# LAKE-TO-LAKES TRAIL

**Public Meeting #2**

**August 27, 2014**

# PROCESS, BUDGET & REVIEW OF COMMENTS

# RRFB Flasher Beacon

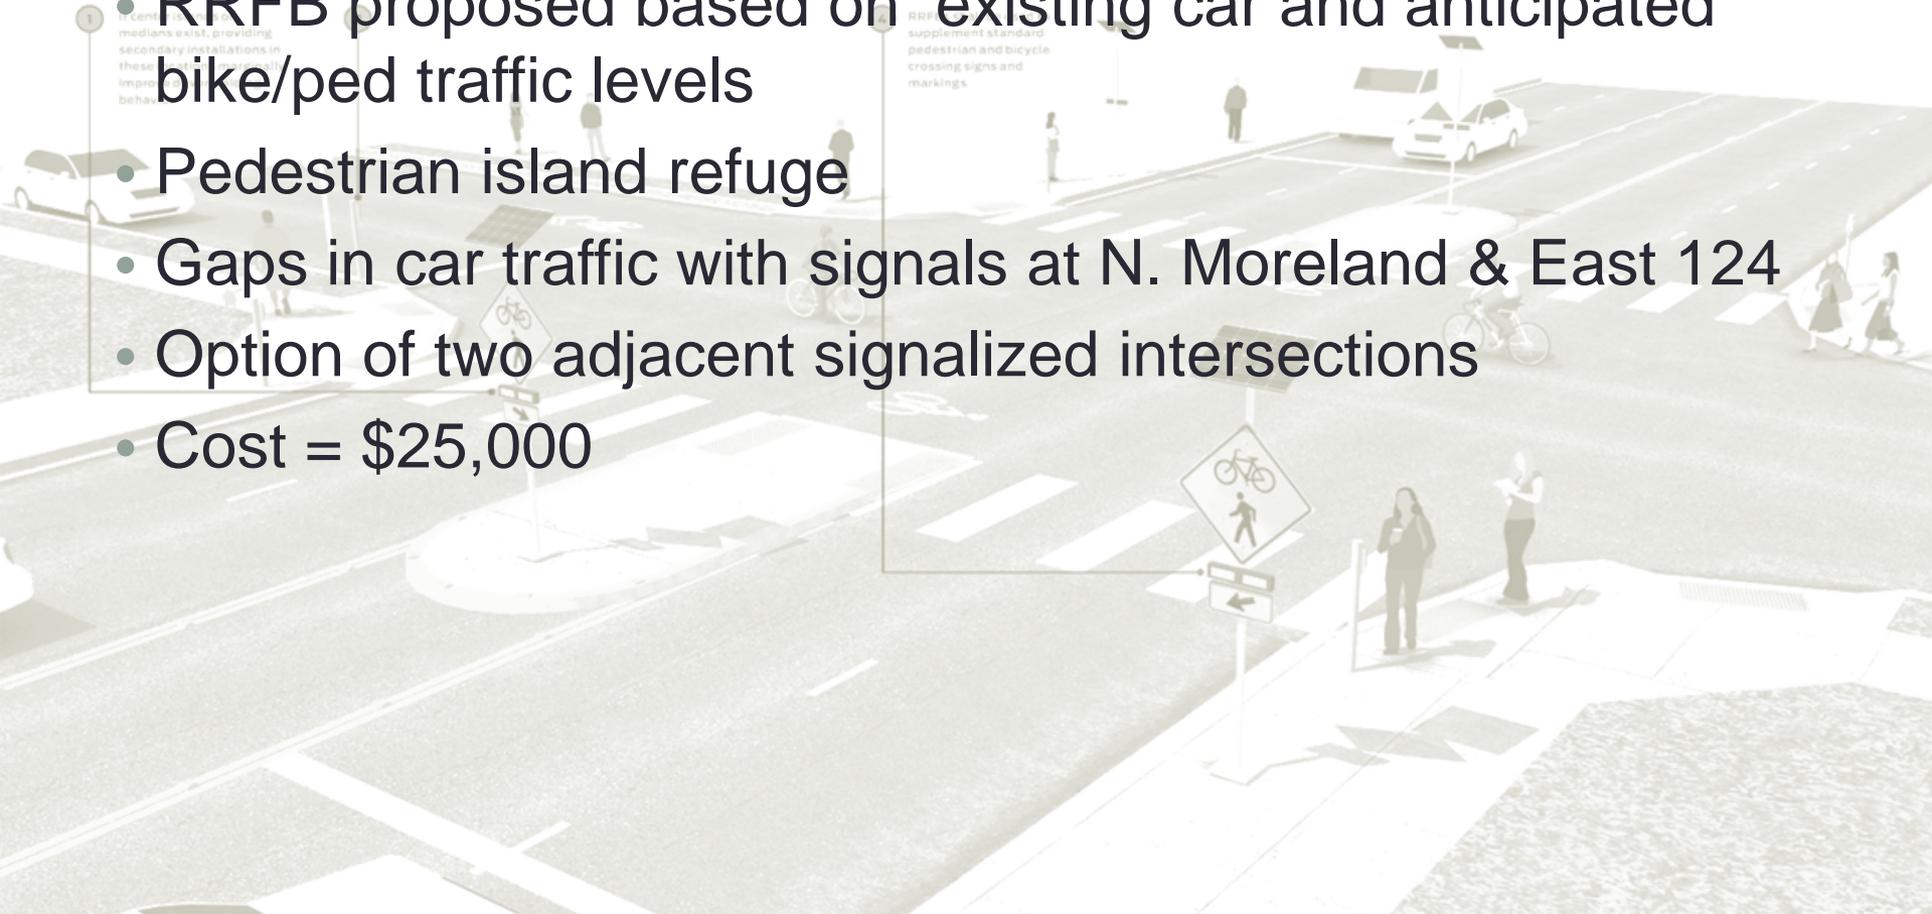
- Fairhill crosswalk beacon/signal @ East 127
- Fairhill crosswalk @ North Moreland/South Park
- Narrowing of trail at bridge

- RRFB proposed based on existing car and anticipated bike/ped traffic levels
- Pedestrian island refuge
- Gaps in car traffic with signals at N. Moreland & East 124
- Option of two adjacent signalized intersections
- Cost = \$25,000
